2020/1523/P	98 Highgate West Hill N6 6NR	Amendments to proposed roof, dormer, side elevation window, side entrance and rear extension as granted by permission ref 2017/5939/P granted 18 December 2017 for erection of single storey lower ground floor rear extension, first floor rear part infill extension, rear and side dormer roof extensions; installation of four rooflights to the side roof slope; infill of first floor south side facing window and addition of first floor obscure glazed north side facing window	Thomas Sild
-------------	------------------------------------	--	-------------

Objection,

Holly Lodge houses between Langbourne Avenue & Makepeace Avenue

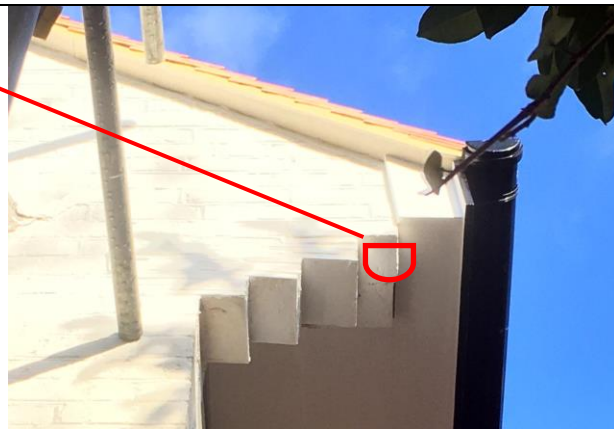
Comparing previous planning applications, 98 & 100 look to have been externally almost identical, other than the placement of the northern chimney, when originally built.

In the statement accompanying the Non-Material Amendment reference is made to 98's ridge height being under the average in the surveyed group, this is irrelevant having more to do with topography and the size of neighbouring properties, 97 being larger & taller.

Original view from attic room

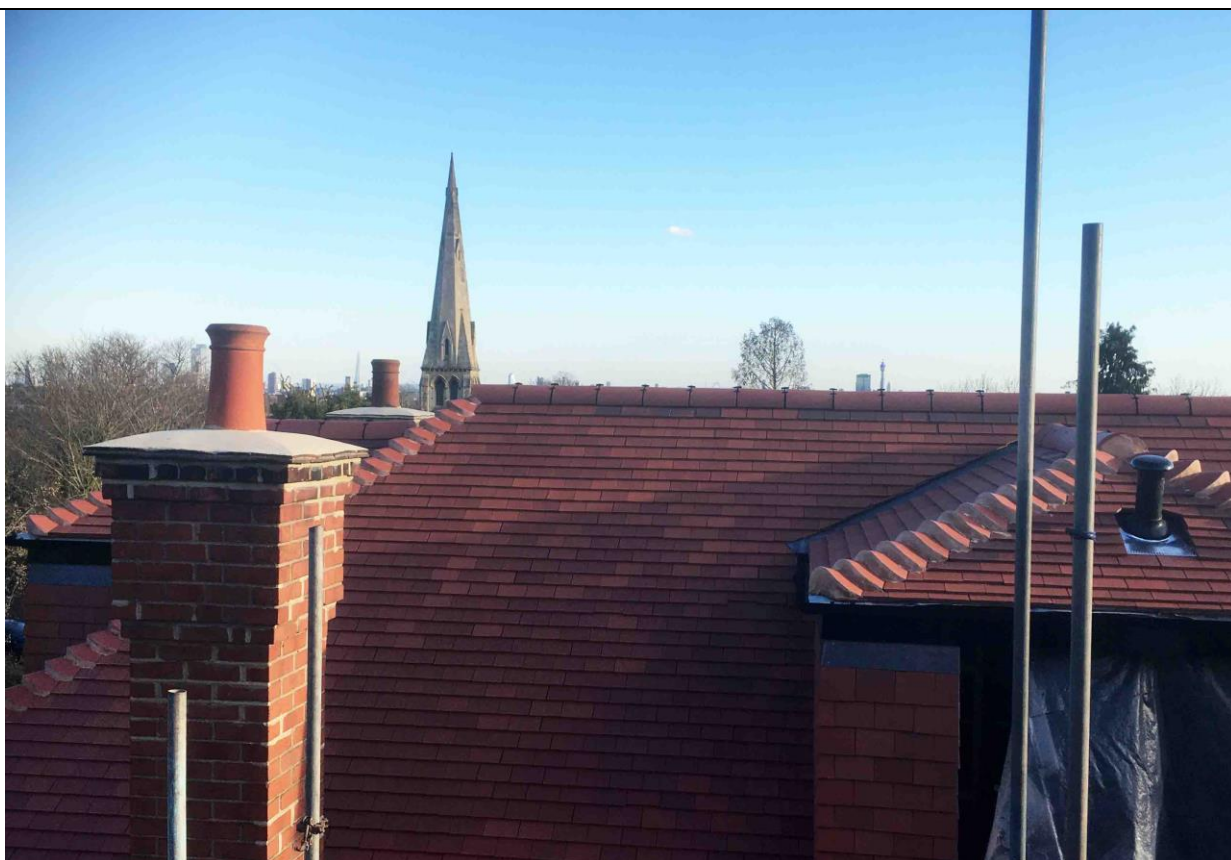
A few years ago the owners of 97 took photographs from their attic room which showed part of the windows in the tower of St Anne's, this view is no longer present and can only be replicated by having the camera outside the room at a level above the top of the window frame.

Current view, note only part of the window in the spire is visible and none of the window in the tower.

Current view from very top of 97 attic window

To match earlier view of church spire camera needs to be raised above the top of the attic window resulting in more of the trees further south being seen.

The NMA Statement suggests that in Fig 3 the above photos are misleading, they are not. The Fig 3 in the NMA Statement still shows that only the window in the spire is visible, the windows in the tower below are still hidden.

The church tower & the window in 97 have not moved
